ORDINANCE NO. _____

An ordinance amending Title 26 – Building Code – of the Los Angeles County Code, to adopt and incorporate by reference the 2025 California Building Code, with certain changes and modifications, and to make other revisions thereto.

FIGURE 1809.3
STEPPED FOOTING

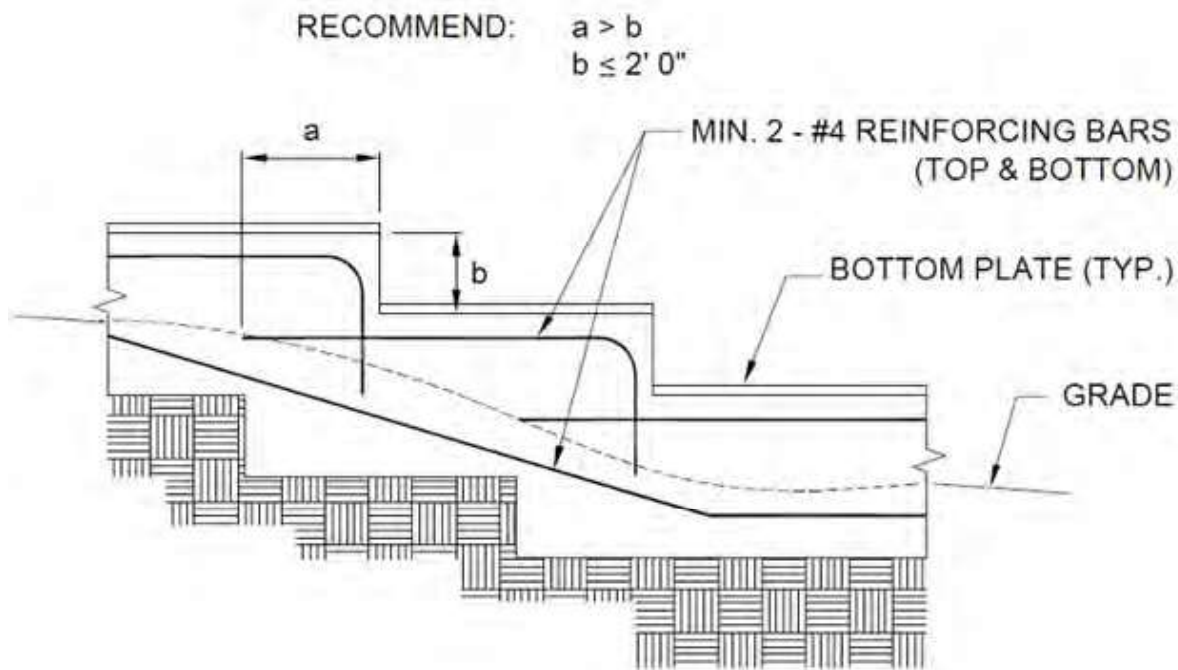
For structures assigned to Seismic Design Category D, E, or F, the stepping requirement shall also apply to the top surface of continuous footings supporting walls.
Footings shall be reinforced with four No. 4 reinforcing bars. Two bars shall be located at the top and bottom of the footings as shown in Figure 1809.3.

SECTION 34. Figure 1809.3 is hereby added to read as follows:

1809.3 and Figure 1809.3	Geological	With the higher seismic demand placed on buildings and structures in this region, it is necessary to take precautionary steps to reduce or eliminate potential problems that may result for under-reinforced footings located on sloped surfaces. Requiring minimum reinforcement for stepped footings is intended to address the problem of poor performance of plain or under-reinforced footings during a seismic event. This amendment is a continuation of an amendment adopted during previous code adoption cycles.
1809.7 and Table 1809.7	Geological	No substantiating data has been provided to show that under-reinforced footings are effective in resisting seismic loads, and therefore they may potentially lead to a higher risk of failure. This amendment requires minimum reinforcement in continuous footings to address the problem of poor performance of plain or under-reinforced footings during a seismic event. With the higher seismic demand placed on buildings and structures in this region, it is necessary to take precautionary steps to reduce or eliminate potential problems that may result by following prescriptive design provisions for footings that do not take into

FIGURE 2308.10.5.1
ALTERNATE BRACED WALL PANEL (ABW)

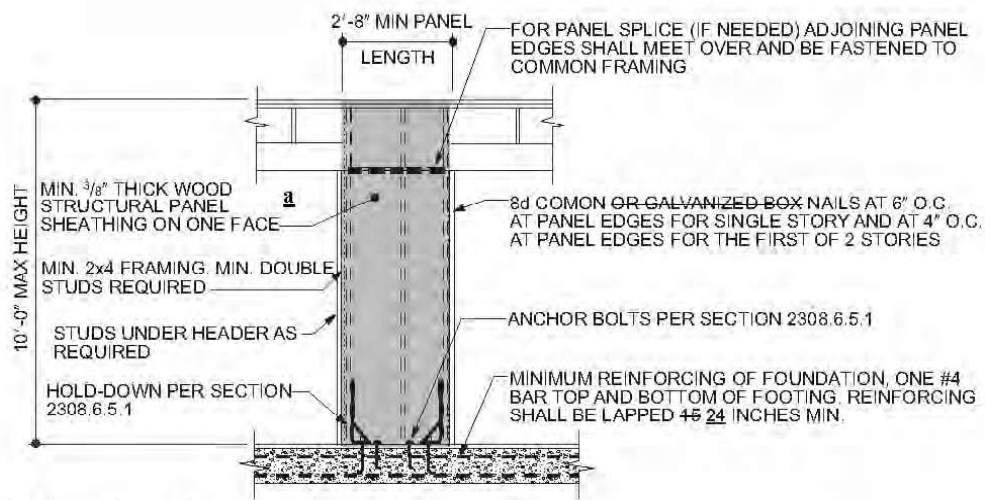
An ABW shall be constructed in accordance with this section and Figure 2308.6.5.1. In one-story buildings, each panel shall have a length of not less than 2 feet 8 inches (813 mm) and a height of not more than 10 feet (3048 mm). Each panel shall be sheathed on one face with 3/8-inch (3.2 mm) minimum-thickness wood structural panel sheathing nailed with 8d common or galvanized box nails in accordance with Table 2304.10.2 and blocked at wood structural panel edges. For structures assigned to Seismic Design Category D or E, each panel shall be sheathed on one face with 15/32-inch minimum-thickness (11.9 mm) wood structural panel sheathing nailed with 8d common nails spaced 3 inches on panel edges, 3 inches at intermediate supports. Two anchor bolts installed in accordance with Section 2308.7.1 shall be provided in each panel. Anchor bolts shall be placed at each panel outside quarter points. Each panel end stud shall have a hold-down device fastened to the foundation, capable of providing an approved uplift capacity of not less than 1,800 pounds (8006 N). The hold-down device shall be installed in accordance with the manufacturer's recommendations. The ABW shall be supported directly on a foundation or on floor framing supported directly on a foundation that is continuous across the entire length of the braced wall line. This foundation shall be reinforced with not less than one No. 4 bar top and bottom. Where the continuous foundation is required to have a depth greater than 12 inches (305 mm), a minimum 12-inch by 12-inch (305 mm by 305 mm) continuous footing ~~or turned-down slab edge~~ is permitted at door openings in the braced

wall line. This continuous footing or ~~turned-down slab edge~~ shall be reinforced with not less than one No. 4 bar top and bottom. This reinforcement shall be lapped ~~15~~24 inches (~~384~~610 mm) with the reinforcement required in the continuous foundation located directly under the braced wall line.

SECTION 55. Figure 2308.10.5.1 is hereby amended to read as follows:

FIGURE 2308.6.5.2
PORTAL FRAME WITH HOLD-DOWNS (PFH)

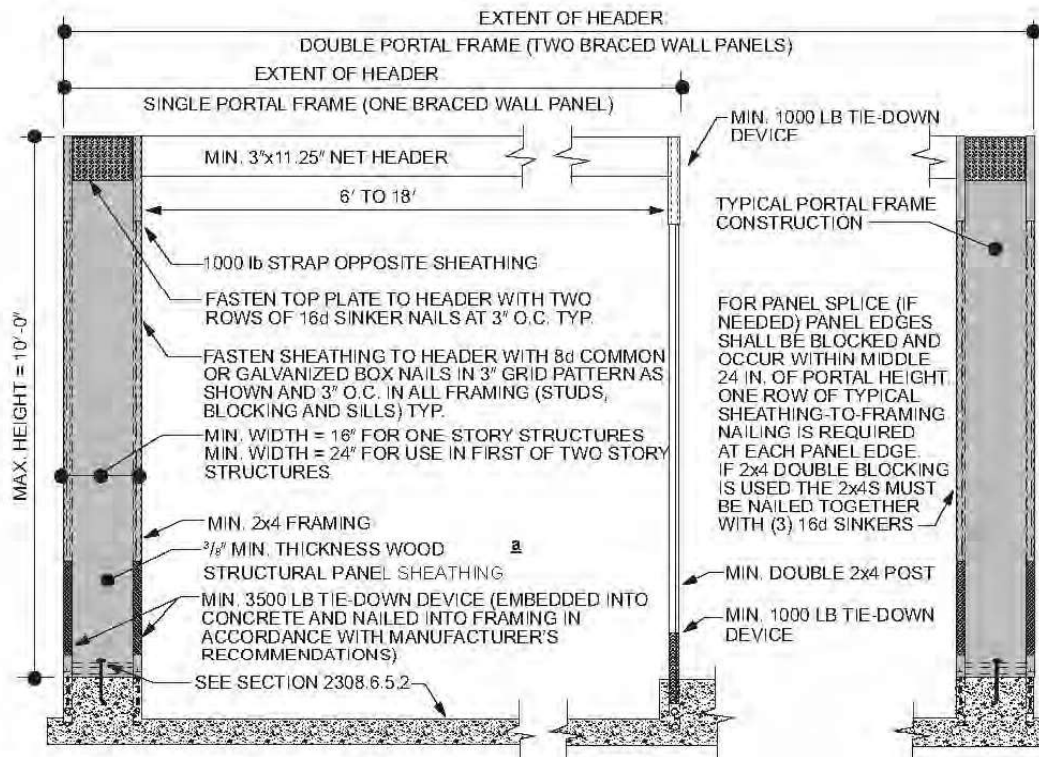
structural panel sheathing nailed with 8d common or galvanized box nails in accordance with Figure 2308.10.5.2. For structures assigned to Seismic Design Category D or E, each panel shall be sheathed on one face with 15/32-inch minimum-thickness (11.9 mm) wood structural panel sheathing nailed with 8d common nails spaced 3 inches on panel edges, 3 inches at intermediate supports and in accordance with Figure 2308.10.5.2. The wood structural panel sheathing shall extend up over the solid sawn or glued-laminated header and shall be nailed in accordance with Figure 2308.10.5.2. A built-up header consisting of at least two 2-inch by 12-inch (51 mm by 305 mm) boards, fastened in accordance with Item 24 of Table 2304.10.1 shall be permitted to be used. A spacer, if used, shall be placed on the side of the built-up beam opposite the wood structural panel sheathing. The header shall extend between the inside faces of the first full-length outer studs of each panel. The clear span of the header between the inner studs of each panel shall be not less than 6 feet (1829 mm) and not more than 18 feet (5486 mm) in length. A strap with an uplift capacity of not less than 1,000 pounds (4,400 N) shall fasten the header to the inner studs opposite the sheathing. One anchor bolt not less than 5/8 inch (15.9 mm) diameter and installed in accordance with Section 2308.3.1 shall be provided in the center of each sill plate. The studs at each end of the panel shall have a hold-down device fastened to the foundation with an uplift capacity of not less than 3,500 pounds (15 570 N).

1,000 pounds (4400 N) shall fasten the header to the bearing studs. The bearing studs shall also have a hold-down device fastened to the foundation with an uplift capacity of not less than 1,000 pounds (4400 N). The hold-down devices shall be an embedded strap type, installed in accordance with the manufacturer's recommendations. The PFH panels shall be supported directly on a foundation that is continuous across the entire length of the braced wall line. This foundation shall be reinforced with not less than one No. 4 bar top and bottom. Where the continuous foundation is required to have a depth greater than 12 inches (305 mm), a minimum 12-inch by 12-inch (305 mm by 305 mm) continuous footing ~~or turned-down slab edge~~ is permitted at door openings in the braced wall line. This continuous footing ~~or turned-down slab edge~~ shall be reinforced with not less than one No. 4 bar top and bottom. This reinforcement shall be lapped not less than ~~15~~24 inches (~~381~~610 mm) with the reinforcement required in the continuous foundation located directly under the braced wall line.

SECTION 57. Figure 2308.10.5.2 is hereby amended to read as follows:

FIGURE J108.1
DRAINAGE SETBACK DIMENSIONS

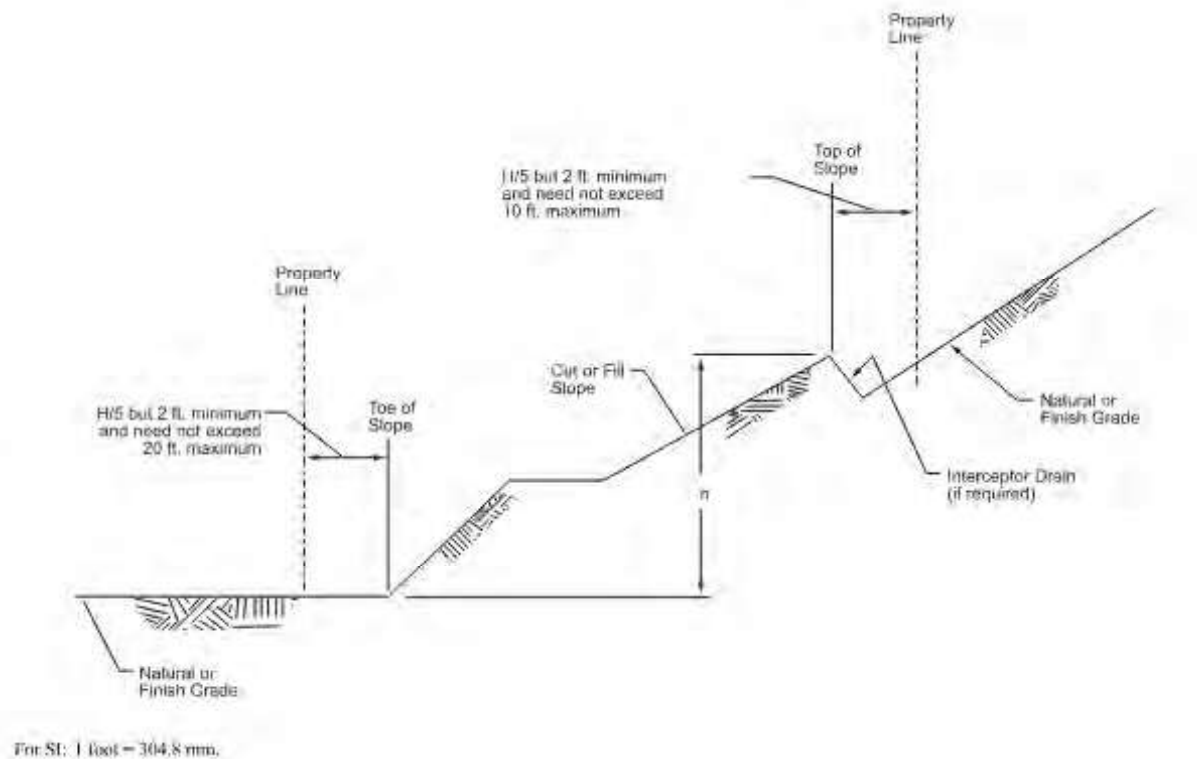
Cut and fill slopes shall be set back from the property lines in accordance with this ~~s~~Section. Setback dimensions shall be measured perpendicular to the property line and shall be as shown in Figure J108.1, unless substantiating data is submitted justifying reduced setbacks, and reduced setbacks are recommended in a geotechnical engineering and engineering geology report approved by the Building Official.

SECTION 79. Figure J108.1 is hereby amended to read as follows:
